Item Name: Crosstube Turning Detail

DART AEROSPACE LTD		Work Order:	116479
Description: Crosstube Assembly		Part Number:	D407-667-245
Inspection Dwg: D407-667-245 Rev: F		Page 1 of 2

DRAWING NO. REV. F
D407-667-245 SHEET 1 OF 4
TITLE SCALE
CROSSTUBE ASSY (407 HIGH AFT) NTS

DRAWING NO. D407-667-245	TITLE CROSSTUBE ASSY (407 HIGH AFT)	REV. F	DART AEROSPACE LTD ENGINEERING ORDER		D.E.O. NO. D407-667-245-F-1	SHEET NO. SHEET 1 OF 2	SCALE NTS
DRAWN <i>JP</i>	CHECKED <i>JP</i>	MFG. APPR. <i>JP</i>	APPROVED <i>JP</i>		DE APPR. <i>JP</i>		
DATE 11.04.08	DATE 11.04.12	DATE 11.04.12	DATE 11.04.12		DATE 11.04.12

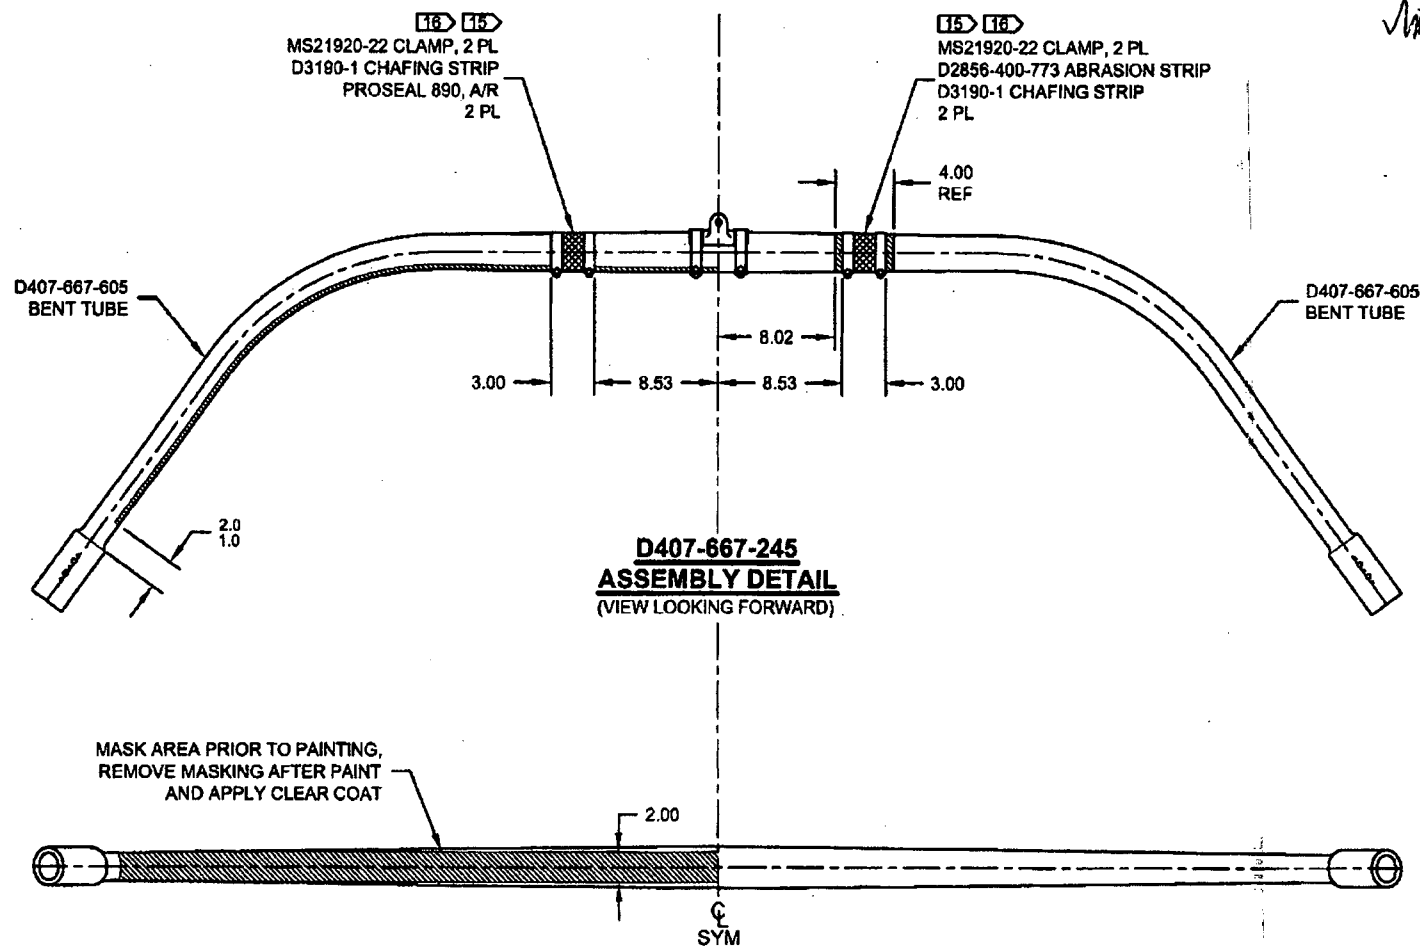
REMOVED ABRASION STRIP IN FAVOR OF A THIN LAYER OF PROSEAL 890.

NOTES 2 AND 15, SHEET 1 ARE AMENDED AS FOLLOWS:

- 2) FINISH: CHEMICAL CONVERSION COAT PER DART QSI 005 4.1
PRIME INSIDE AND OUTSIDE PER DART QSI 005 4.2
MASK UNDERSIDE OF CROSSTUBE AS SHOWN (HATCHED AREA) AND
PAINT OUTSIDE PER DART QSI 005 4.2
REMOVE MASKING AND APPLY CLEAR COAT
- 15) APPLY A THIN COAT OF PROSEAL 890 ON INSIDE CONCAVE SURFACE OF D3190-1
CHAFING SHIELDS AND LET CURE PER MANUFACTURER'S INSTRUCTIONS. INSTALL
PROSEAL D3190-1 CHAFING SHIELDS ONTO CROSSTUBE BY APPLYING A THIN COAT
OF PROSEAL 890 ONTO CROSSTUBE. BE SURE TO ELIMINATE ANY AIR GAPS.

- 2) FINISH: CHEMICAL CONVERSION COAT PER DART QSI 005 4.1
PRIME INSIDE AND OUTSIDE PER DART QSI 005 4.2
PAINT OUTSIDE PER DART QSI 005 4.2
- 15) INSTALL D2856-400-773 ABRASION STRIP WITH A 0.13 REF GAP ON BOTTOM SIDE OF
CROSSTUBE PER QSI 035.
